SERVICE LETTER NO. 7

SUBJECT: CONVERSION OF MODEL 15AC LANDPLANE TO MODEL S15AC SEAPLANE

SUPPLEMENT No. 1 TO SERVICE LETTER No. 7, DATED JULY 21, 1948.

SUPPLEMENT NO. 2 TO SERVICE LETTER NO. 7 DATED JULY 21, 1948.

Sketch for use with Supplement No. 1 to Service Letter No. 7 dated July 21, 1948

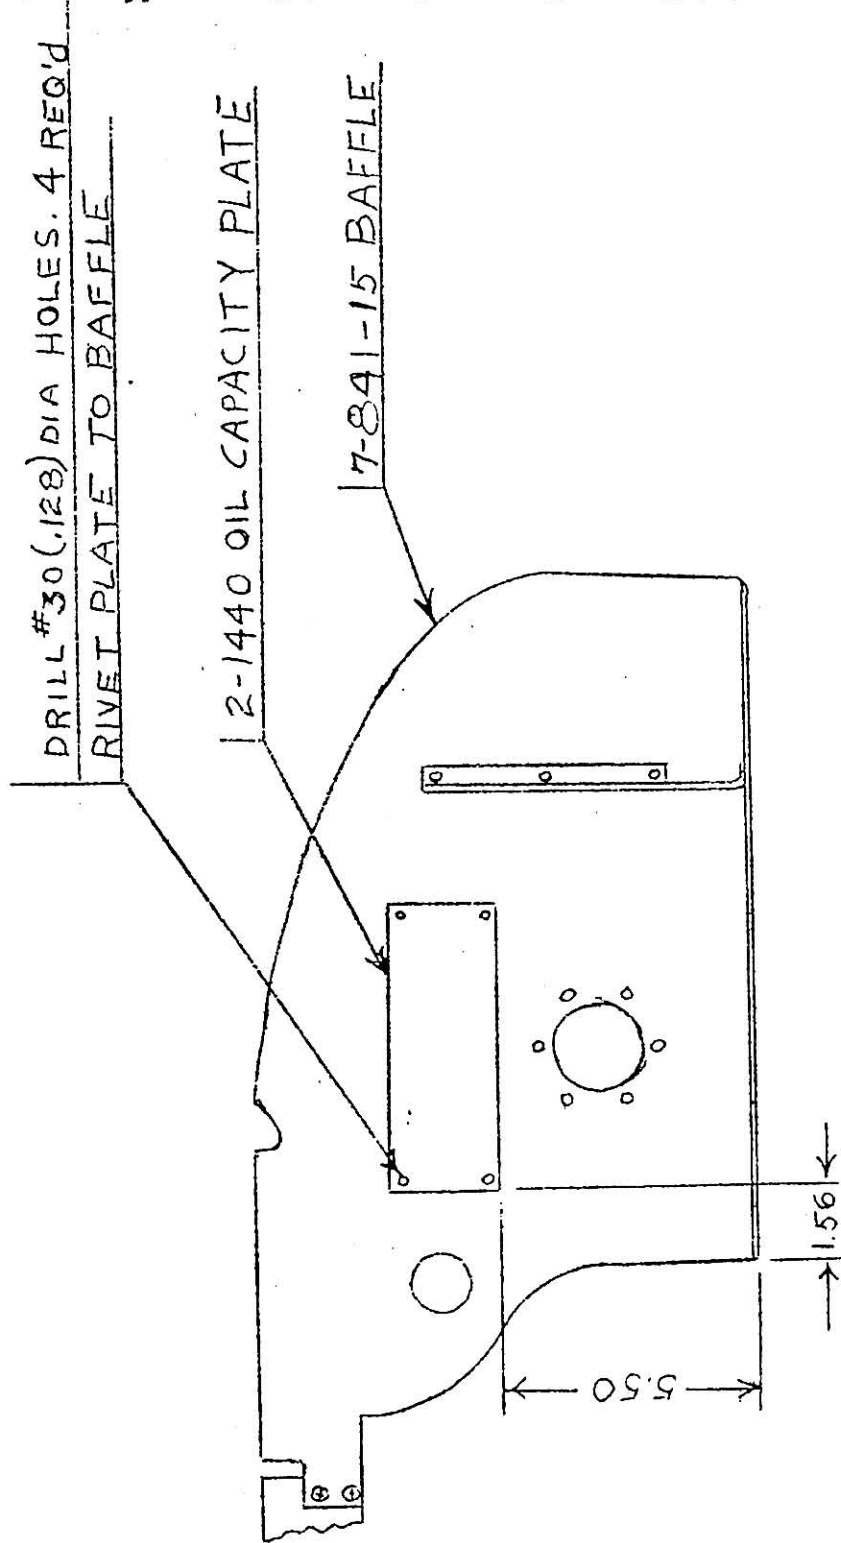
In Service Letter No. 7 we listed a number of changes that are required in order to convert a Model 15AC to a Model S15AC Seaplane. In addition to those changes, it is now mandatory that a 2-1440 oil capacity plate be added to the 7-841-15 left rear engine baffle.

This plate is important when servicing Model S15AC Seaplanes, due to false oil gauge readings, when the airplane is in normal water attitudes.

2-1440 oil capacity plates are now available and may be purchased from our Parts Department. Installation should be accomplished in accordance with the attached sketch.
